**Re: Whirlpool Corporation, Fort Smith, Arkansas
January 22, 2013 ADEQ Review of Revised Risk Management Plan
EPA No. ARD042755389 AFIN No. 66-00048**

GROUNDWATER TRENDS
 WHIRLPOOL CORPORATION
 6400 JUNNY LIND ROAD
 FORT SMITH, ARKANSAS

FIGURE
 7

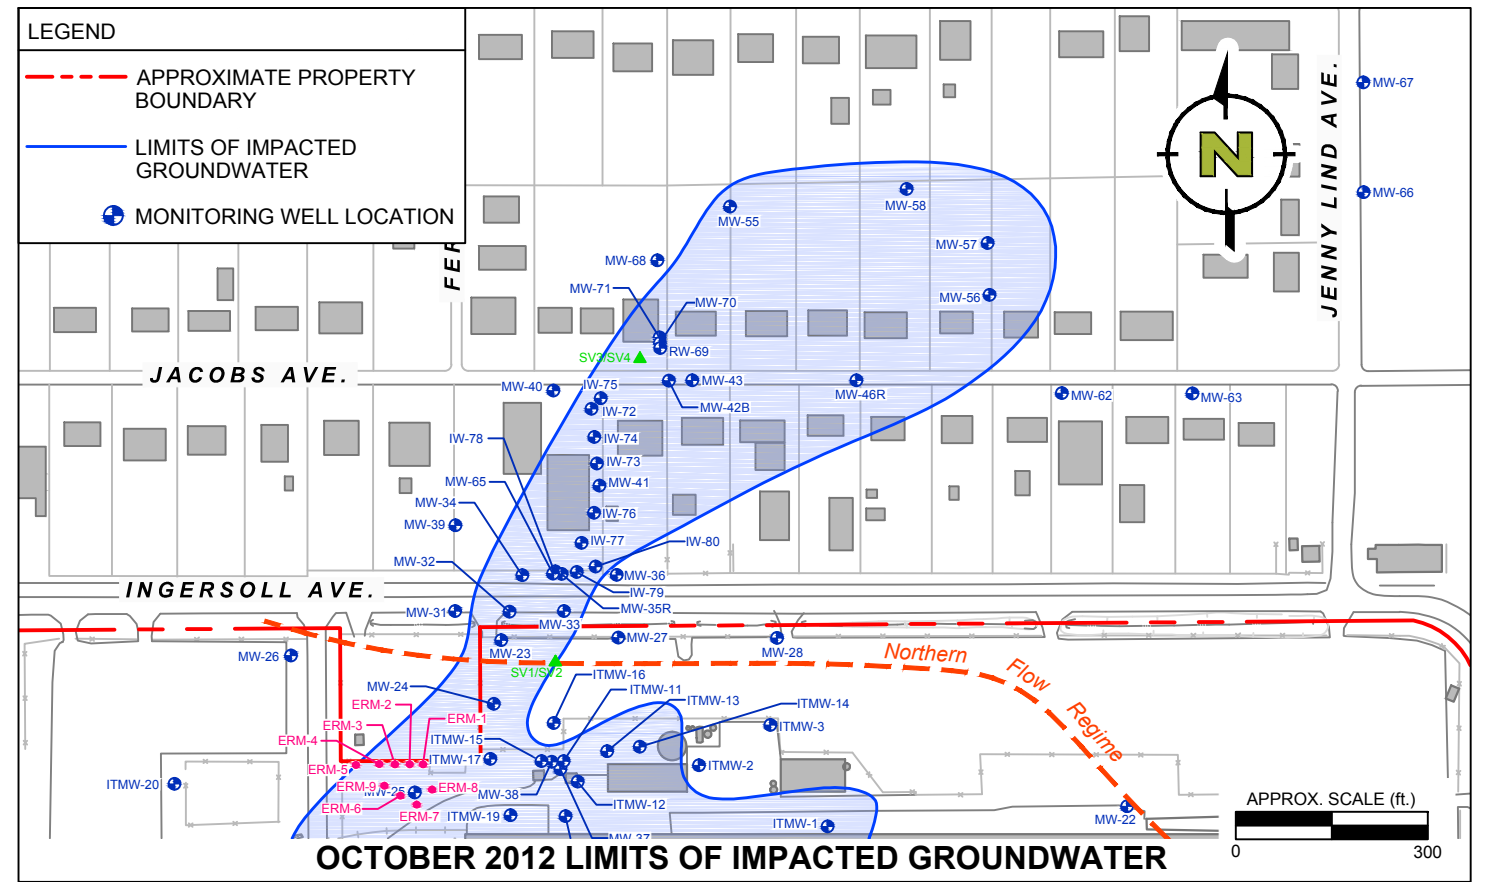
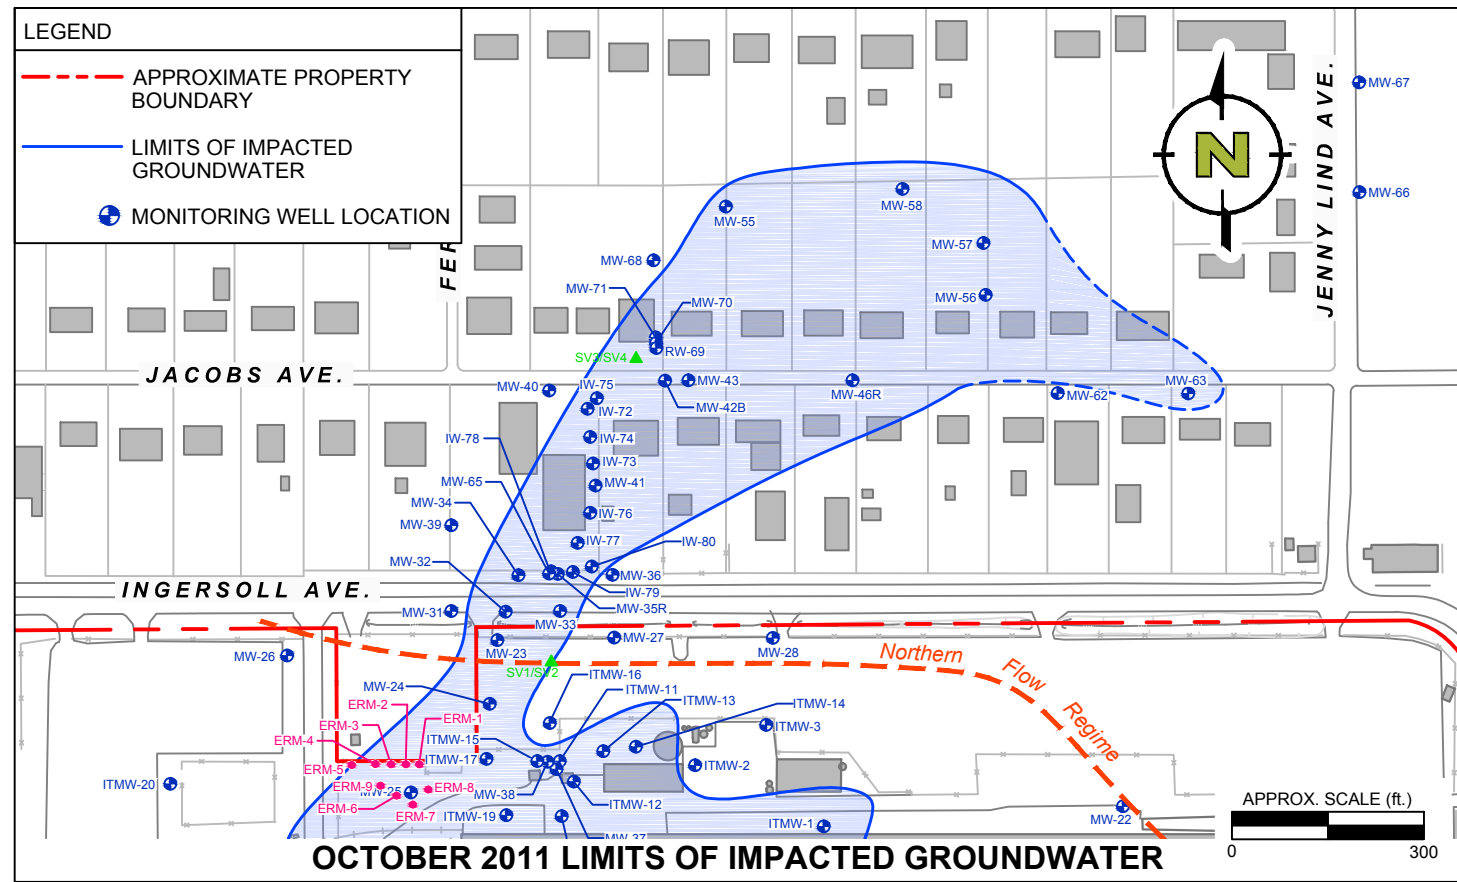
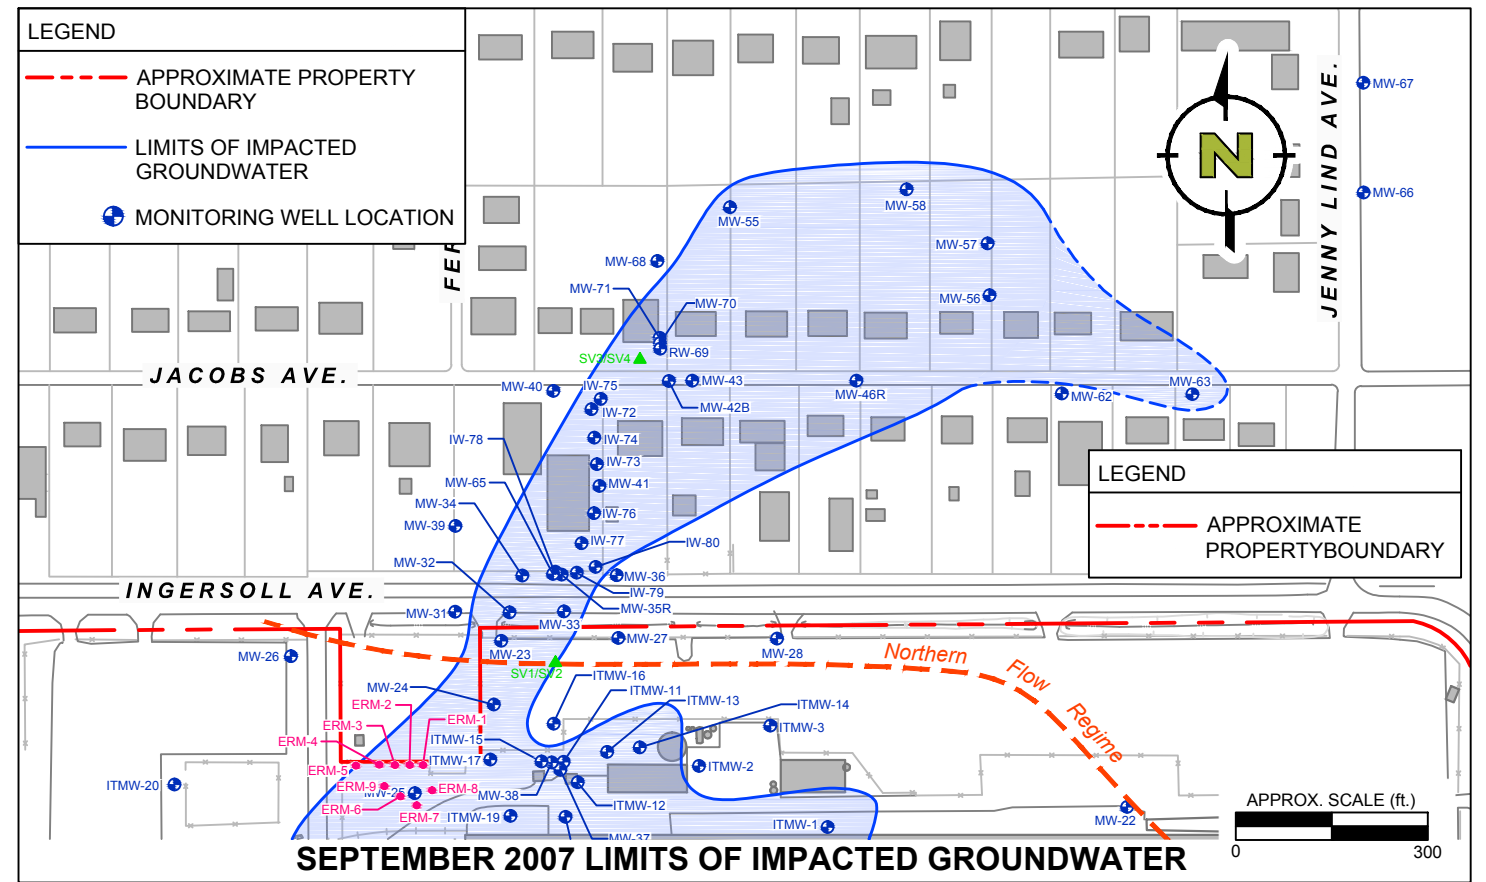
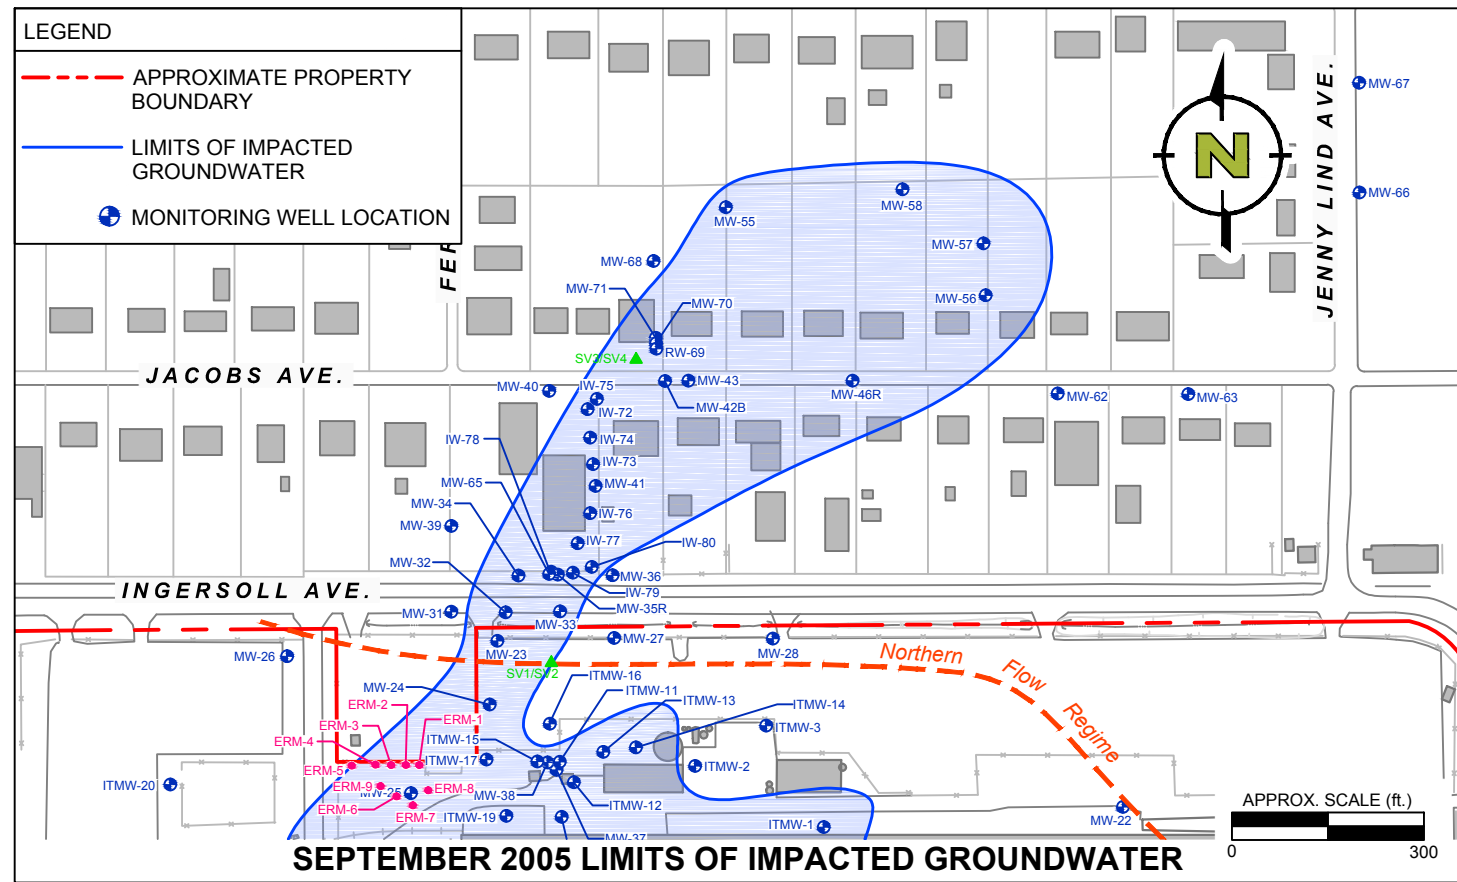
This follow-up letter is in response to the January 22, 2013 letter discussing ADEQ's review of the Revised Risk Management Plan (RRMP) for the Whirlpool Fort Smith, AR project site. While we understand that trichloroethylene (TCE) concentrations exist off-site in concentrations above maximum contaminant levels (MCL) which will be addressed with institutional controls, we would like to discuss the second sentence of the response letter which states "*the contamination plume appears to still be moving*".

ENVIRON reviewed groundwater data collected for the site over time and developed the attached groundwater trends figure (Figure 1). This figure depicts four different fall groundwater data collection events from the time period of 2005 through 2012. Data collected between the years of 2005 and 2012 were chosen to represent the most complete data sets, as prior to 2005 many wells had either not yet been installed and/or full rounds of data sets were not available. As shown on Figure 1, the only modification of the original on-site and off-site plume delineation of impacted groundwater is the inclusion of MW-63 in the 2007 and 2011 events.

Based upon 7 years of data, TCE concentrations appear to be stable to decreasing at the northern flow regime boundary and stable at off-site boundary wells. These data indicate that the TCE plume has a defined delineation and there is no continued migration of TCE further off-site.
